Modification To A Standard Part

502A812 THRU 845 - G07

R TRIMMED

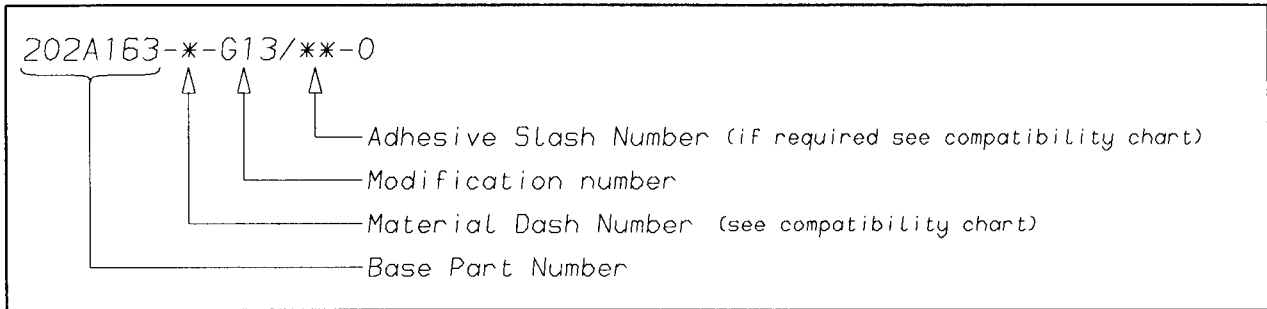
R
	+/-10%
	b
502A812	33
502A823	40
502A834	50
502A845	50
